COMMONWEALTH OF MASSACHUSETTS
ENERGY FACILITIES SITING BOARD

Milford Power, LLC Notice of Project Change

)
)
)
EFSB 17-04

TENTATIVE DECISION

Figure 1. Water Truck Delivery Routes to the Facility

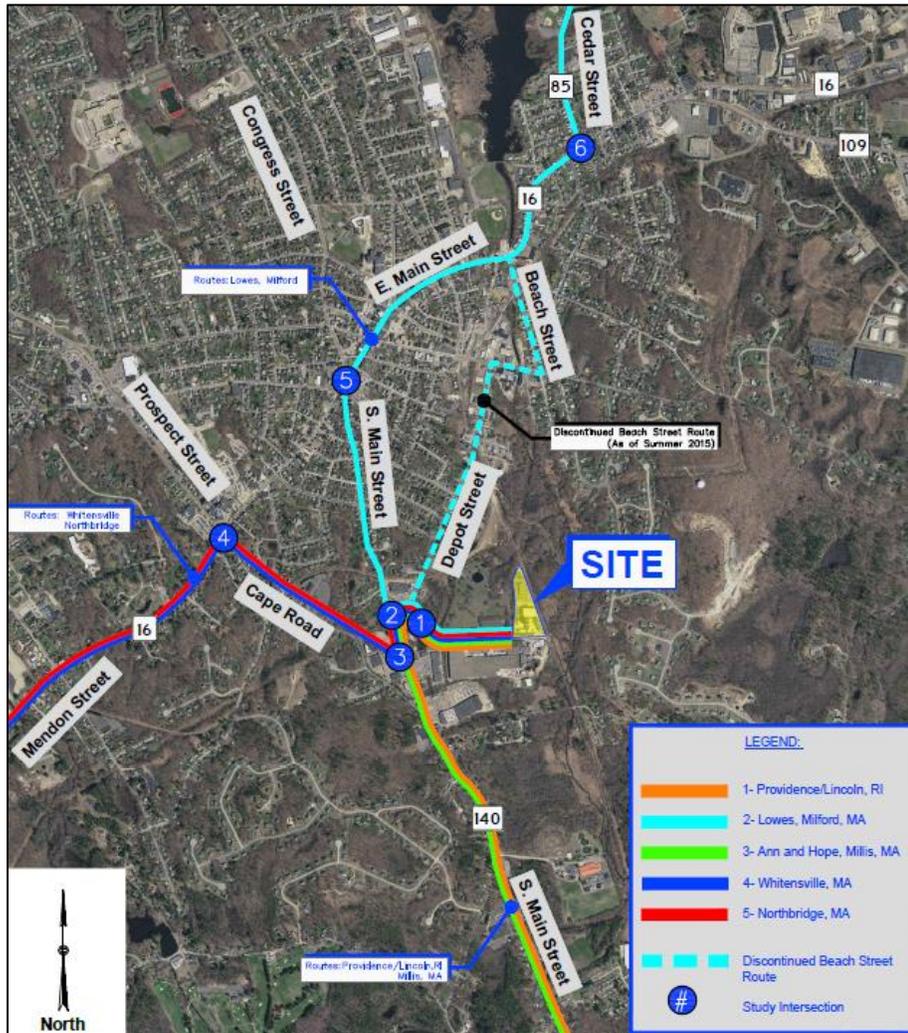
¹⁹ Milford Power stated that any trucked water necessary to meet incremental needs of the Project Change would be sourced from outside of the Charles River watershed, in effect limiting incremental truck traffic impacts to roads shown as routes 1, 4, and 5 in Figure 1, above (Exhs. MP-10, at 1-15; EFSB-P-3(1) at 105; Tr. 1, at 159-161).

The record shows that construction-related traffic from the Project Change would be limited in volume and duration. While the Company committed to prohibiting all delivery traffic on Beach Street, the Siting Board also directs the Company to prohibit construction-vehicle traffic on Beach Street.

Within five years of the completion and initial operation of the Project Change, should trucked water deliveries to the Facility exceed 90 percent of the 2.02 MGD level evaluated for traffic impacts (i.e., exceed 1.82 million gallons on any one day) on five or more days in a calendar year, the Company shall submit to the Siting Board an annual report by January 15th of the following year. The report shall detail the number of days that 1.82 million gallons of water or more was trucked to the Facility, the volume of truck traffic entering and exiting the Facility on an hourly basis for each day, and any traffic complaints the Company received. After five years, the Company shall consult with the Siting Board to determine whether the Board will require continued reporting, as it deems appropriate. The Siting Board finds that, with implementation of the above conditions, the traffic impacts of the Project Change would be minimized.
